Release Notes: ISW Series 8-Port Industrial Switches

Firmware Version 1.01.04.0001 (for all models)

ISW 4-10/100P, 2-10/100T, 2-SFP, PoE Switch (FE)
ISW 4Gbp, 2GbT, 2-SFP, PoE Switch (GE)

Documentation Date: 2022/02/28

- Balancing Chain with LAG

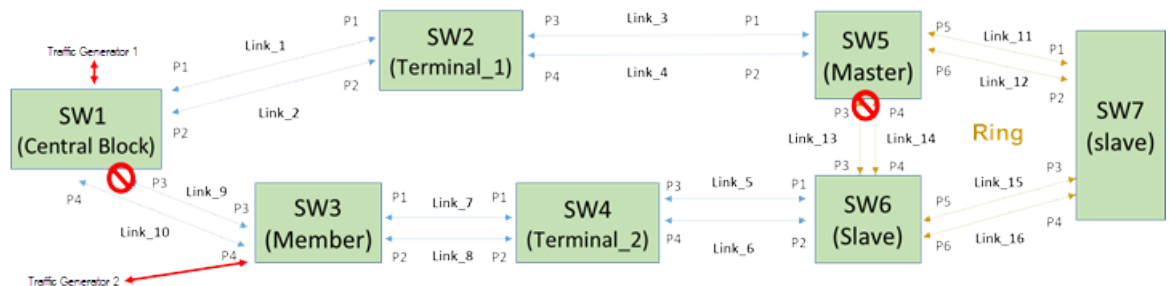
1. Support Dual Ring (Ring/Chain with LAG)
 - ➔ This feature is supported in all Ring, Chain, Coupling, Dual-homing, and Balancing Chain technologies.
- Restrictions of Dual Ring:
 - Each LAG Ring node supports only 2 ports of LAG
 - Ring topologies that have STP mixed with LAG Ring nodes are not supported
 - Only Static LAG is supported

Average recovery time is same as original Ring technologies (similar to rings without LAG). The recovery time is sub-50 ms.

State chart of 802.1X/MAC auto sense mode

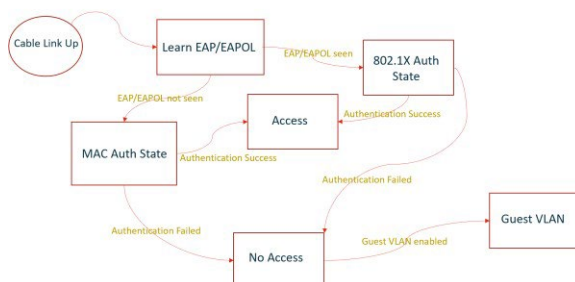
2. Support “Enable both MAC and 802.1X auth on same port”
➔ 802.1X/MAC Auth auto sense mode.

- Mode States:
 - Try to authenticate through 802.1X else
 - Try to authenticate through MAC else
 - Provide Guest VLAN access (if Guest VLAN is enabled) else
 - No Access
